METROPOLITAN GOVERNMENT OF NASHVILLE AND DAVIDSON COUNTY

STAFF RECOMMENDATION
2008 18th Avenue South
July 17, 2013

Application: Partial demolition; New construction—addition
District: Belmont-Hillsboro Neighborhood Conservation Zoning Overlay
Council District: 18
Map and Parcel Number: 10412025800
Applicant: David Dorris
Project Lead: Melissa Baldock, melissa.baldock@nashville.gov

Figure 1. 2008 18th Avenue South

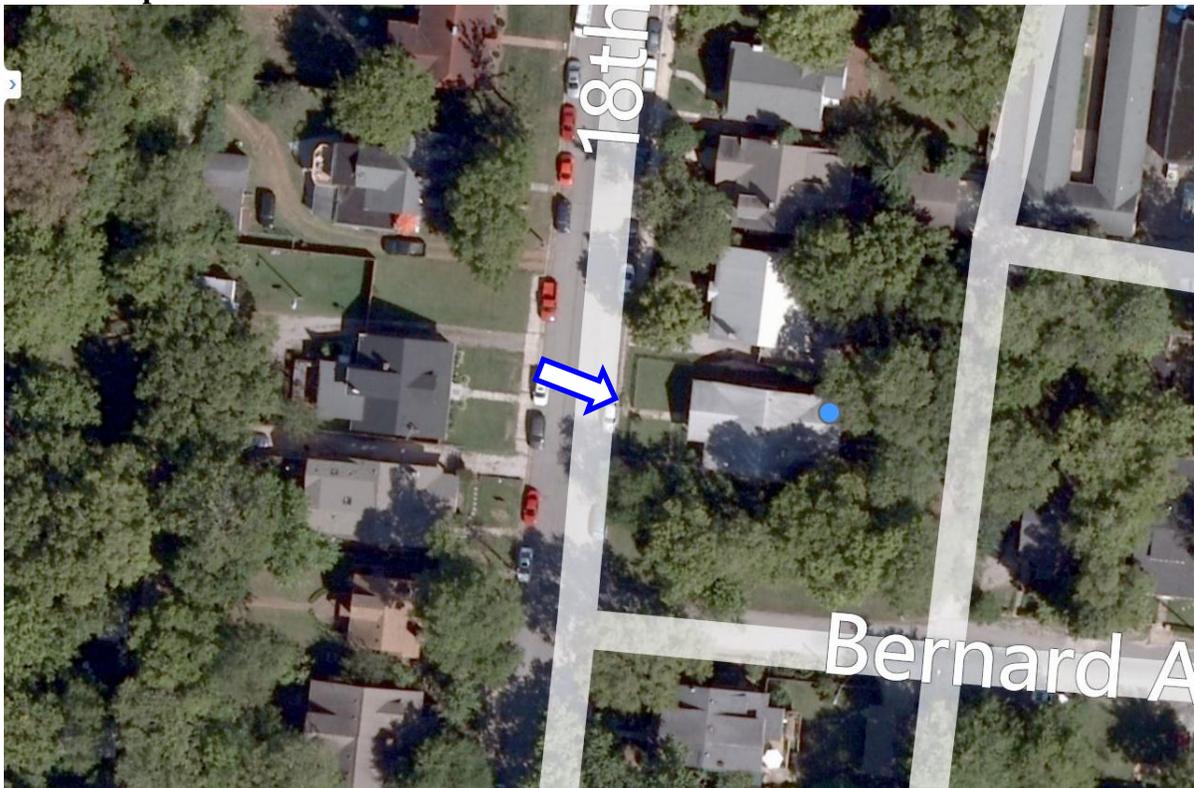
Background: 2008 18th Avenue South is a brick bungalow constructed c. 1930.

SITE + FIRST FLOOR PLAN

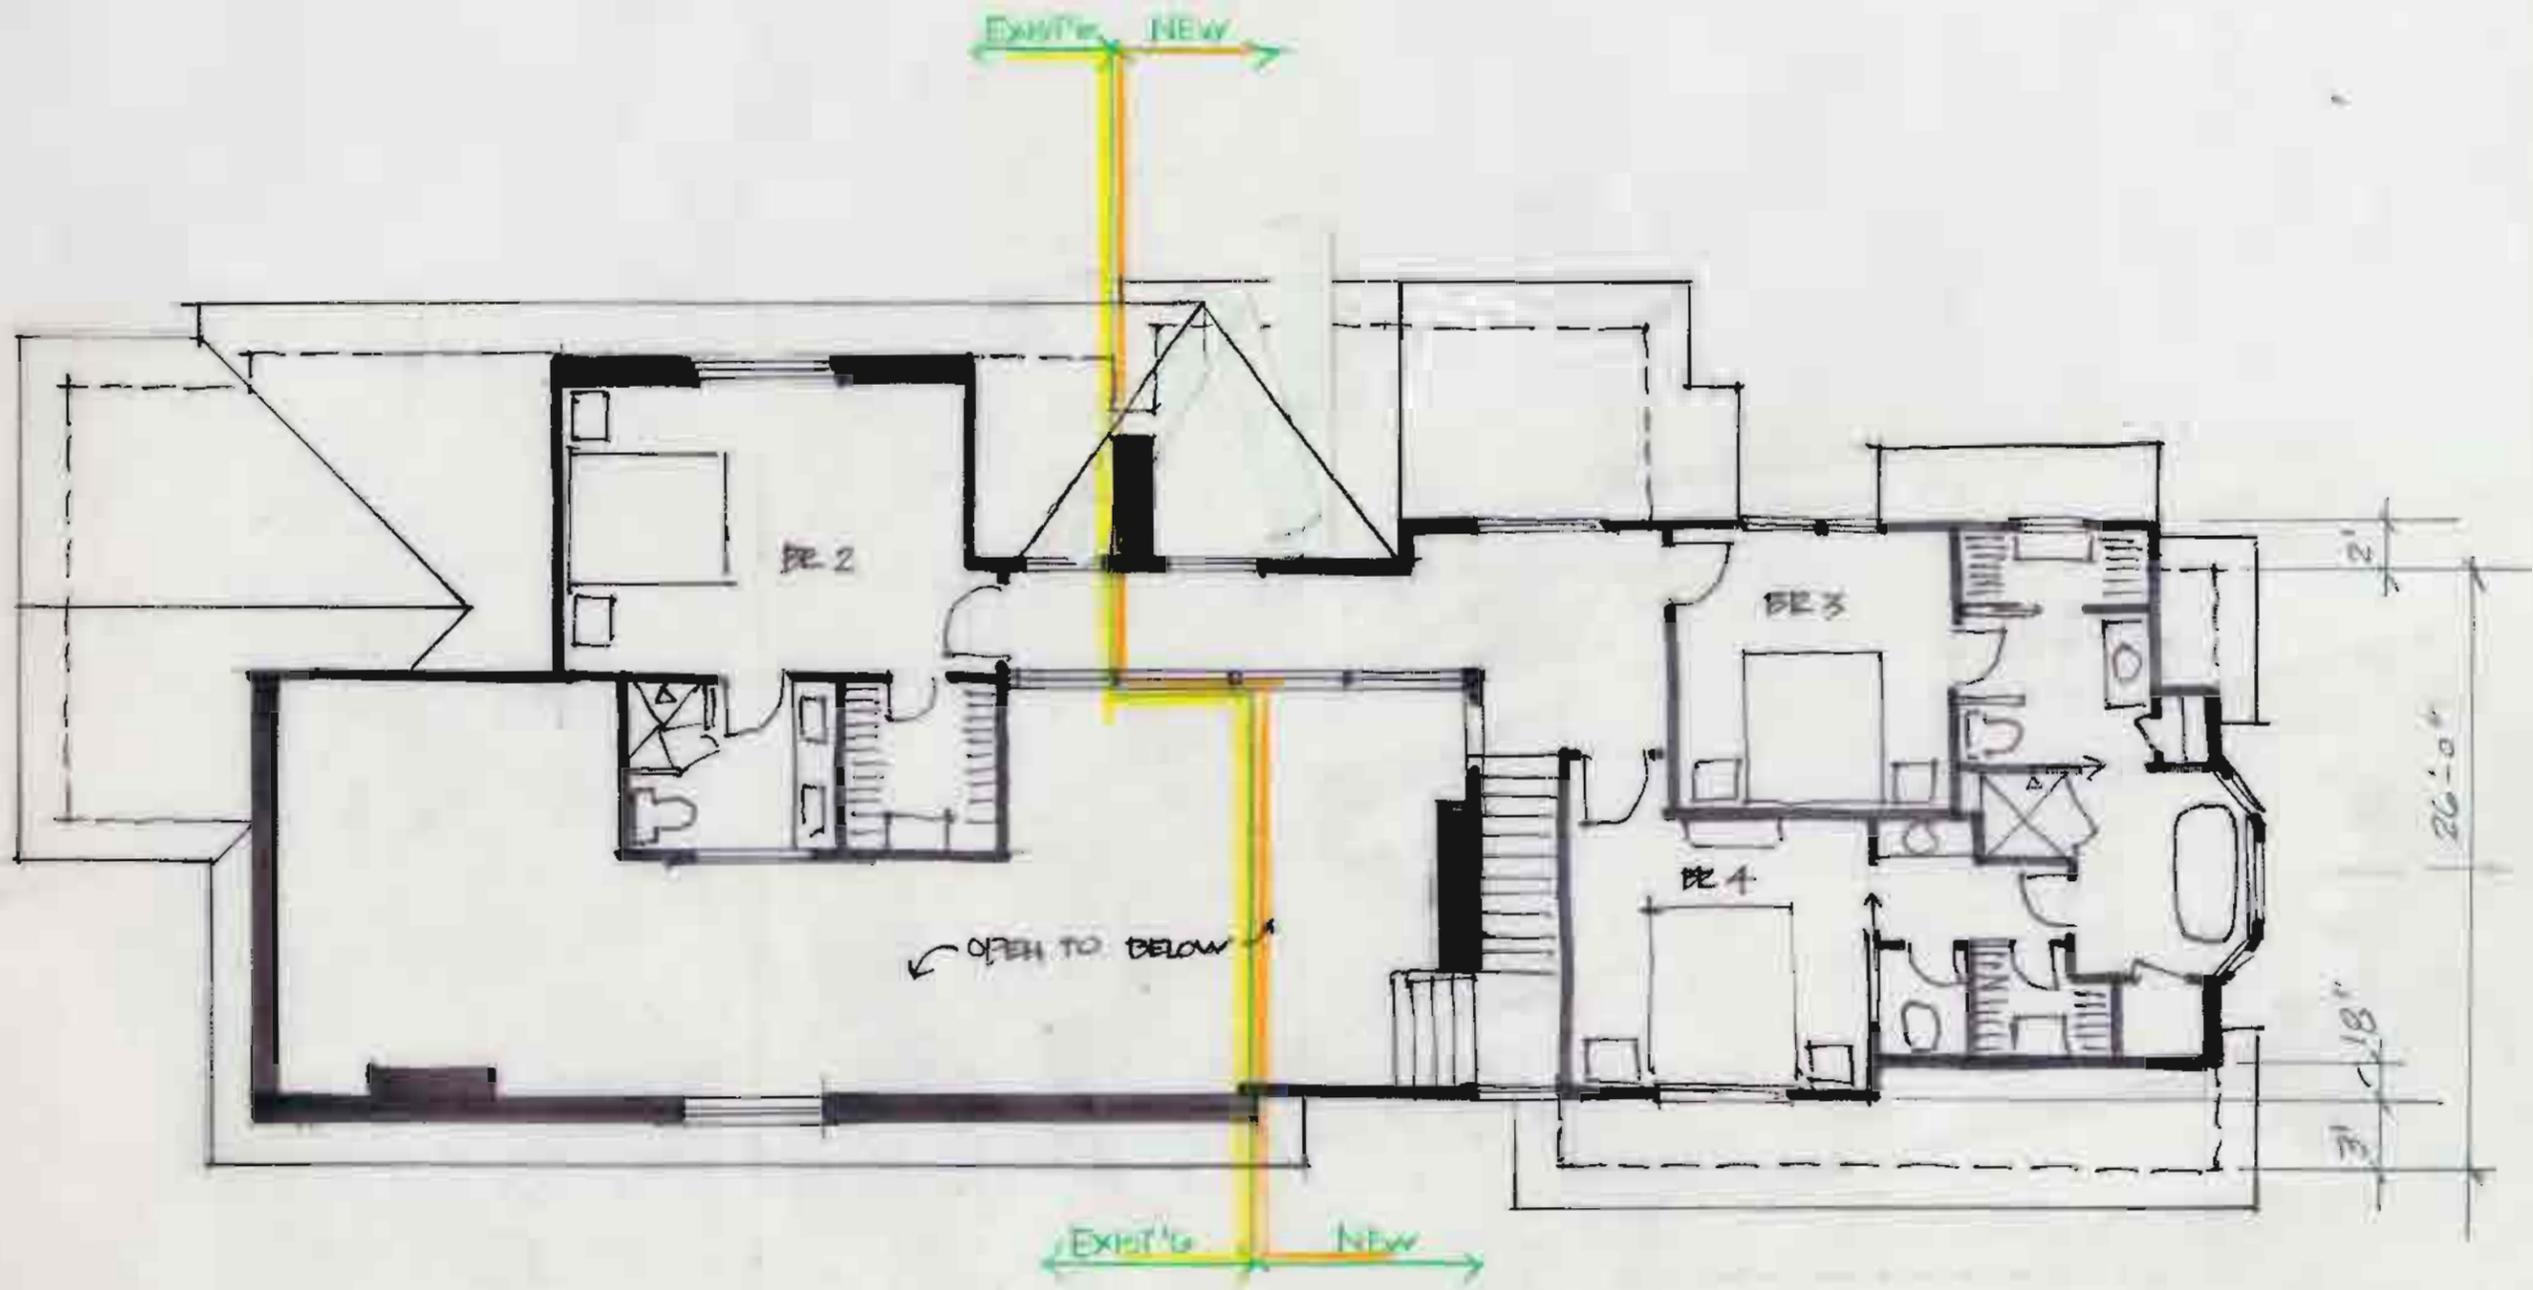
Location, Setback: The addition meets base zoning requirements for setbacks. On the right/south side, the addition at its maximum width will be five feet (5') from the side property line. On the left/north side, the addition will be approximately eight feet (8') from the side property line. The addition will be twenty feet (20') from the alley/rear property line. Staff finds that the location and setback of the addition meets Sections II.B.1.c and II.B.2. of the *Belmont-Hillsboro Neighborhood Conservation Zoning Overlay: Handbook and Design Guidelines*.

Height, Scale: The majority of the historic house is approximately thirty-three feet (33') wide; this does not include bays on both the north and the south side of the addition, each of which extend between one and two feet (1-2') beyond the house. On the right/south side, the addition steps in approximately one foot (1') from the sidewall of the historic house. The addition will approximate the location and inset of the existing addition that is to be demolished. After a depth of thirteen feet (13'), the addition steps back out to be approximately two feet (2') wider than the back wall of the historic house. This wider portion of the addition will line up with, and will be no wider than, the house's side bay (Figure 5).

On the left/north façade, the addition will step in two feet (2') from the sidewall of the house for a depth of two feet (2'). After this initial inset, the addition will step back out to match the line of the bay on the existing house (Figure 6). The addition will be approximately two feet (2') wider than the back wall of the historic house. This wider portion of the addition is an enclosed one-story porch. Staff finds the massing to be appropriate since the bulk, the two-story portion of the addition, is only nineteen feet (19') wide where it connects to the historic portion of the house. The majority of the left side of the addition is the one-story porch and a raised deck. Staff finds the insets and the width of the addition to meet the design guidelines because the back corners of the historic house will be preserved and the addition will be no wider than the historic structure's bays.

Outbuilding: An attached, two-bay garage is proposed. Attached garages are not generally appropriate; however, the Commission has allowed for them when they are located at the basement level, located at the rear of the home, and located in the general vicinity of historic outbuildings. The garage is located at the basement level, at the rear of the property, where a garage would have typically been located. Its doors face the alley, and it will be accessed via the alley. Staff therefore finds that the garage meets Section II.B.1.i. of the *Belmont-Hillsboro Neighborhood Conservation Zoning Overlay: Handbook and Design Guidelines*

SOUTH ELEVATION

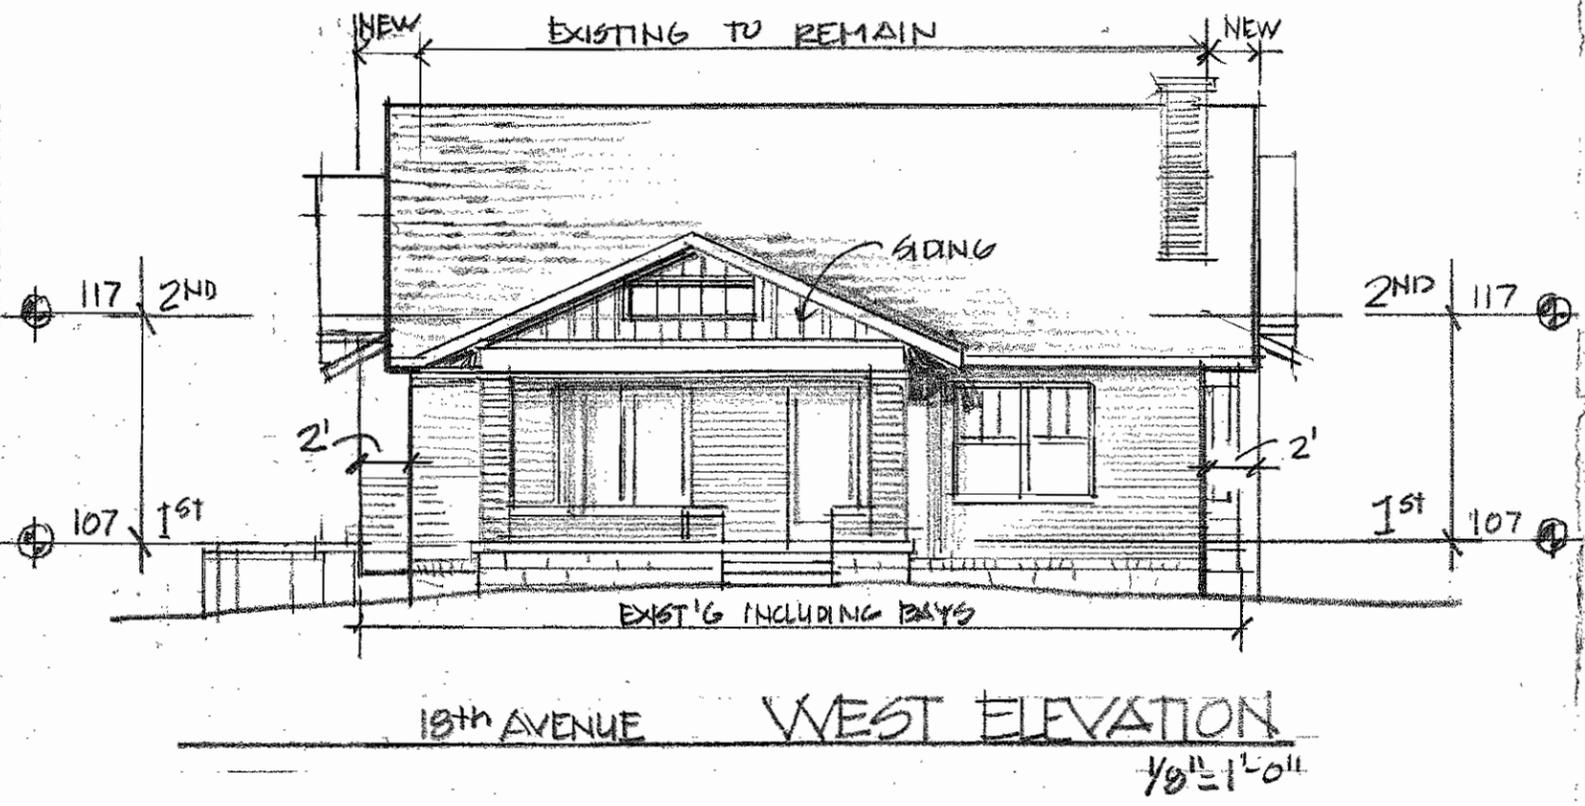
Two changes are proposed for the window openings on the historic house. On the right/south elevation, a window at the back will be enlarged. Staff finds this alteration appropriate because the window opening is at the back of the historic house, is located beyond the bay. Its alteration will not significantly impact the historic character of the structure. Also, the enlarged window opening meets the historic proportions of window openings. On the left/north elevation, the pair of double hung windows on the bay will be replaced with a horizontal strip of windows. This window opening appears to be original to the house, and is visible from the street. Staff therefore asks that it be retained. Staff asks that a condition of approval be that this window opening remain unaltered.

1. Staff approve the trim material, a stone sample, a brick sample, window and door specifications, and the roof material and color;
2. The siding have a maximum reveal of five inches (5")
3. The window openings on the left/north side bay remain unaltered; and,
4. The utilities be placed in the rear of the property, or on a side façade, beyond the midpoint of the property.

NORTH ELEVATION

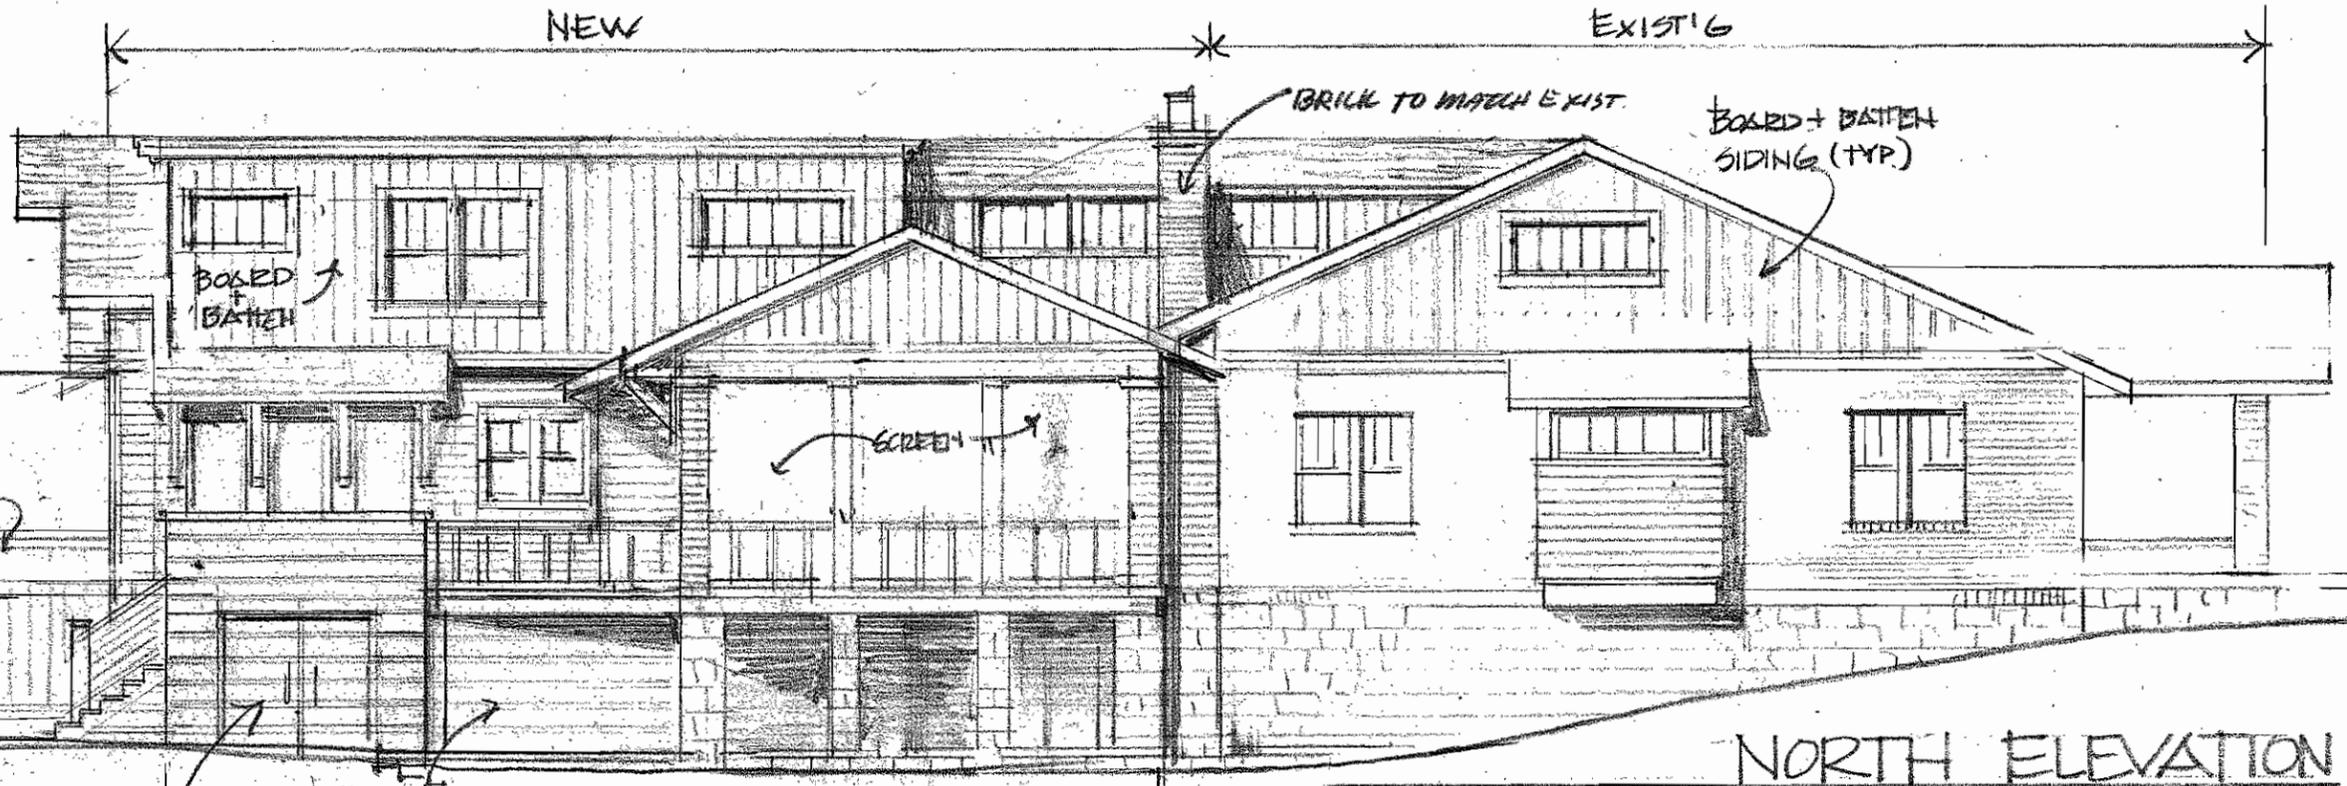
Roof Form: The historic house has a side gabled roof form with a slope of approximately 5.25/12. The addition's gable roofs will largely match the existing roof slope. However, on the left/north façade, a portion of the roof will be flat. Typically, roofs should have a slope of at least 6/12 or should match the slope of the historic house. Staff finds this flat roof acceptable in this instance because the roof form will be inset approximately nine feet (9') from the line of the historic house, and the roof is towards the back of the addition. At most, this roof form will be minimally visible. Staff there finds that the addition's roof forms are compatible with that of the house and with surrounding historic structures, and meet Sections II.B.1.e. and II.B.2. of the *Belmont-Hillsboro Neighborhood Conservation Zoning Overlay: Handbook and Design Guidelines*.
